## Narrows pump station SRM rehabilitation Wareham MA Reels arrangement to line through manhole (pos 87+25)

# Modified plan to line pass through manhole (pit 12) pos 87+25

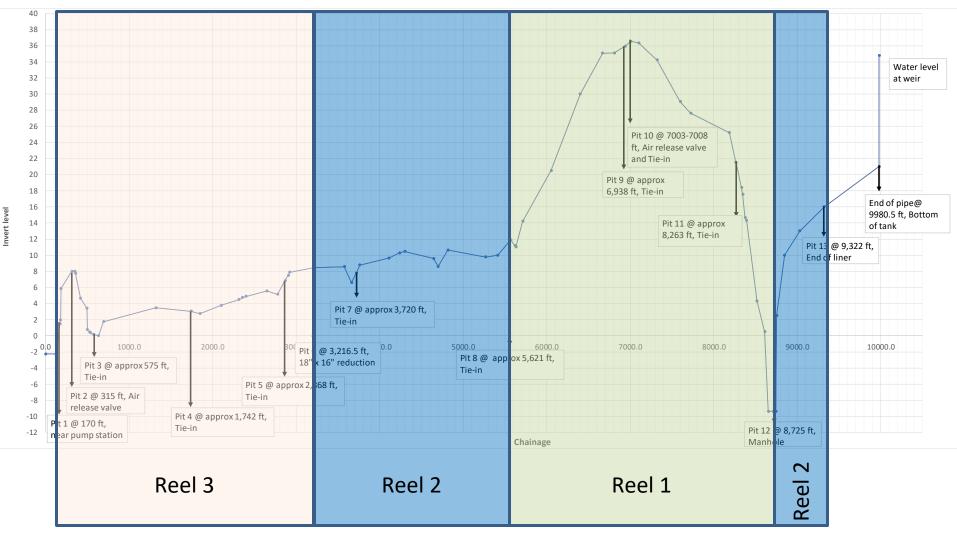
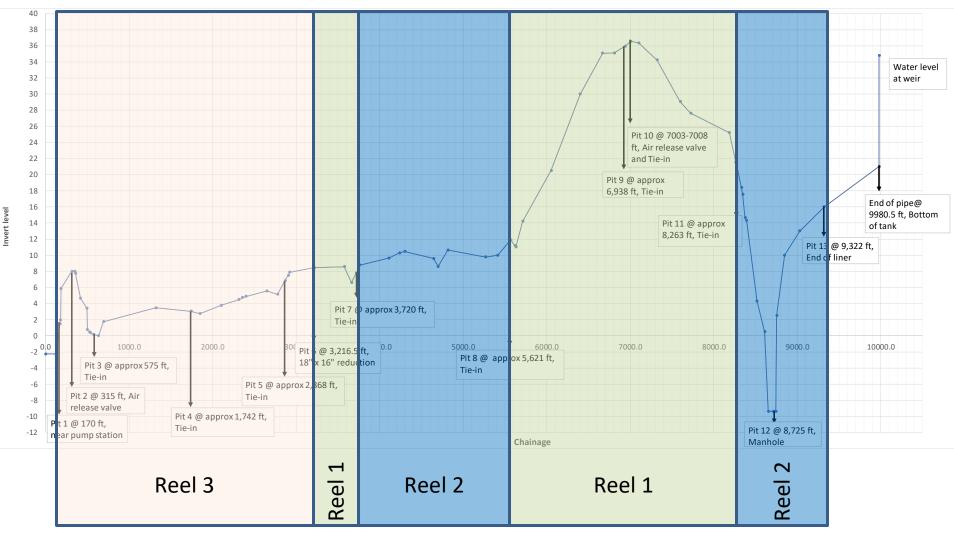
- In order to accommodate the liner in the reels to the project for the contractor to be able to line through the manhole at position 87+25 some re-arrangements in the reels usage and in the number of pulls is needed
- Since pit 12 will not be have connectors installed in this modified plan, more liner length will be needed for that specific pull, this changes the usage of the liner in the reels.
- The liner lenghts sent in the reels was design with the original plan in mind.
- This modified plan will require 8 pulls instead of 7
- If it is decided to line pass through the manhole at position 87+25 the following reels arrangement and usage have to be followed to rehabilitate the pipeline.

- The liner was shipped in three T-600 reels (6m)
- Reel 1 with 3,207.00 LF of 18" liner
- Reel 2 with 3,083.00 Lf of 18" liner
- Reel 3 with 3,182.00 LF 16" liner
- Reel 1 to be used to line the section between pit 8 and pit 11, and sectoin between pit 6 and pt 7
- Reel 2 to be used to line the section between pit 11 and pit 13 and the section between pit 7 and pit 8
- Reel 3 to be used to line the section between pit 1 and pit 6
